Re: Woodview Golf Subdivision, Township of North Kawartha

Transportation Impact Study - Response to Peer Review Comments

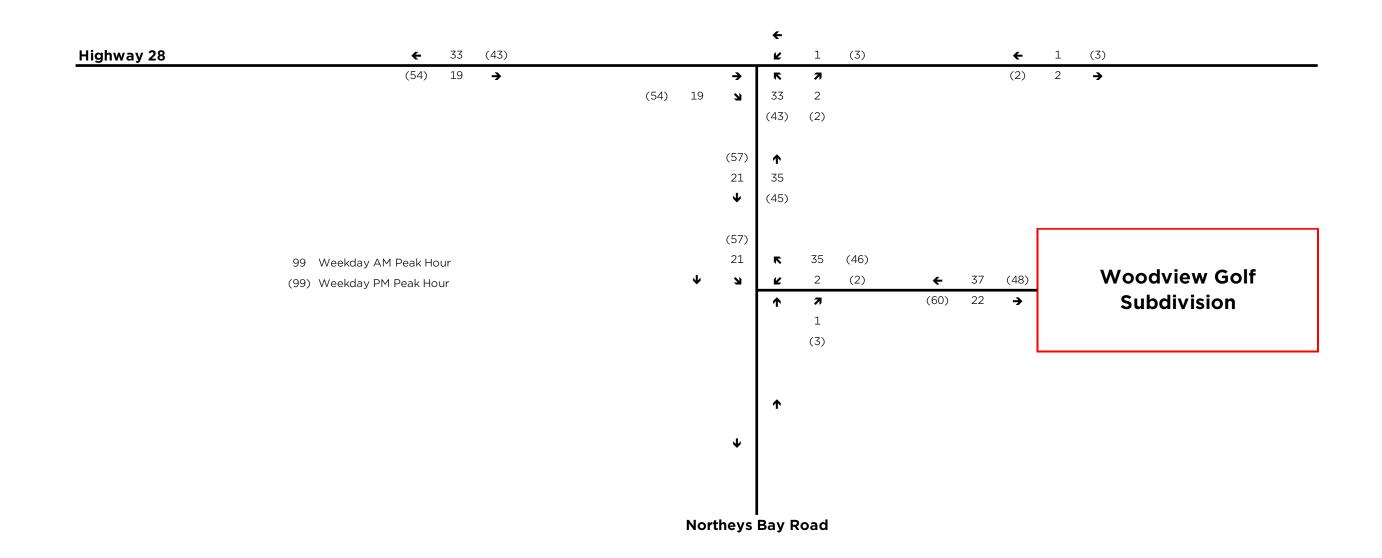
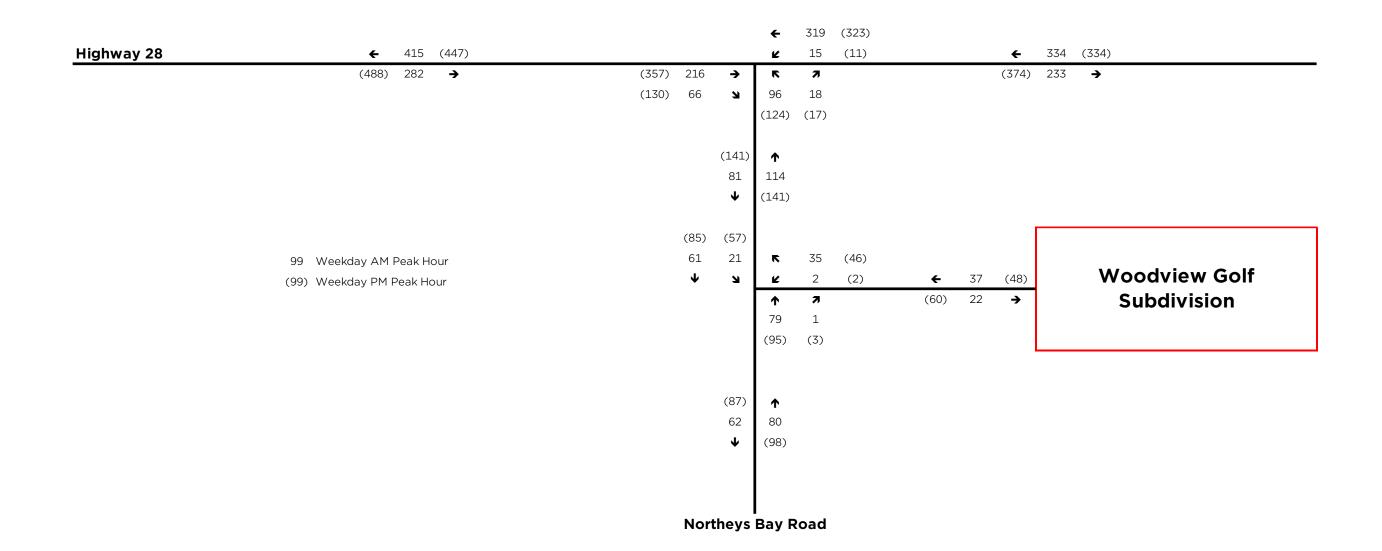
Comment #9: Please provide further information on how the available sight distances in Table 11 were calculated. Given the vertical alignment of the road and a review of the site access location via Google Street View, the available sight line may be less than 120 meters reported.

Tatham Response: The original sight distances were measured and photographed in the field in accordance with *Schedule "A"* of *By-Law 2024-25* (2012-26 previously) and therefore provide a more accurate representation than Google Street View. Regardless, a supplementary site visit was conducted to re-affirm the available sight distances along Northeys Bay Road at the site access. The sight distances

were assessed in accordance with *By-law 2024-25*. For a posted speed limit of 60 km/h, the required minimum sight distance is 130 m.

Based on the field assessment, the available sight distance to/from the north is 137 metres; whereas the sight lines to/from the south are approximately 136 metres. Photographs from the field visit are provided in Figure 3.

Based on the field measurements, the sight lines at the proposed access are appropriate, satisfying the County's sight distance requirements in all instances.

2037 Total Traffic - AM Peak Hour

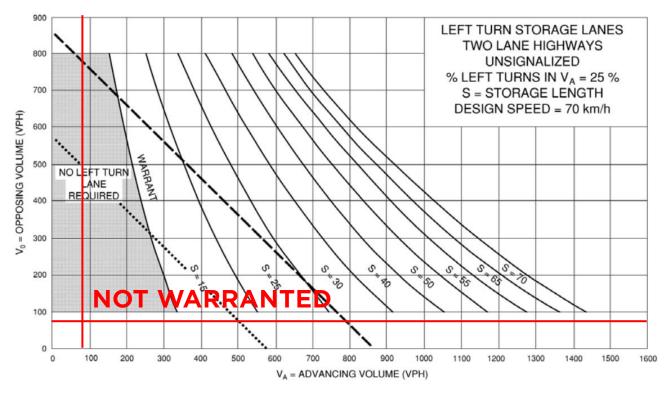
Comment #7: Turn lane requirements should be updated based on revised horizon years, updated trip generation calculations, and adjusted turning movement volumes to reflect potential summer traffic increases.

Tatham Response: The revised left turn monographs are provided in Appendix B and are reflective of 2037 total traffic conditions volumes considered herein. As noted, a left turn lane on Northeys Bay Road at the site access is not warranted. Nor is a northbound right turn lane warranted given the limited volume of right turning traffic accessing the site.
